Planning and Zoning Board

Staff Report

CASE NUMBER: ZON18-00470
LOCATION/ADDRESS: The 200 block of North Signal Butte Road (east side) and the 10800 block of East Mercury Drive (south side).
GENERAL VICINITY: Located south of University Drive on the east side of Signal Butte Road
REQUEST: Rezoning from RS-9 to RSL-2.5-PAD; and Site Plan Review, also consider the preliminary plat for "Montelucia"
PURPOSE: This request will allow for the development of a single-residence subdivision
COUNCIL DISTRICT: District 6
OWNER: Funk Family Enterprises
APPLICANT: Mark Funk, Funk Family Enterprises
STAFF PLANNER: Cassidy Welch

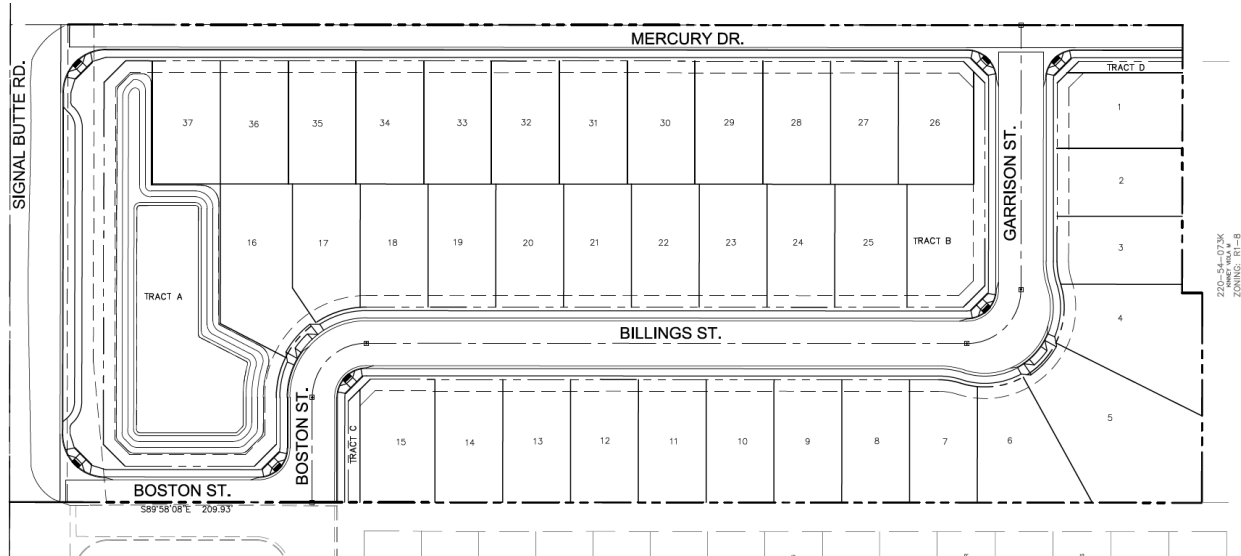
The application is proposing 4 floor plans with 3 elevations each. Below are examples of the included product design. Full elevations and floor plans are provided for Board review with the supplemental materials included in the Planning and Zoning Board packet.

Façade Articulation Waiver:

Per section 11-5-3.E, a façade articulation waiver may be requested for the requirement to set the garage façade back 3' from the primary wall. Façade articulation waivers can only be approved for subdivisions with more than 25 lots and is only applicable to a maximum of 40% of the lots in the subdivision. The façade articulation would apply to a maximum of 14 of the proposed 37 lots in the development. The application is requesting a façade articulation for the "Spanish Colonial" elevation of 3 floor plans. The design of the "Spanish Colonial" elevations makes it difficult to extend the entryway without creating awkward and unusable space. Due to the high-quality architectural design and use of real materials, staff has no concerns with the proposed façade articulation.
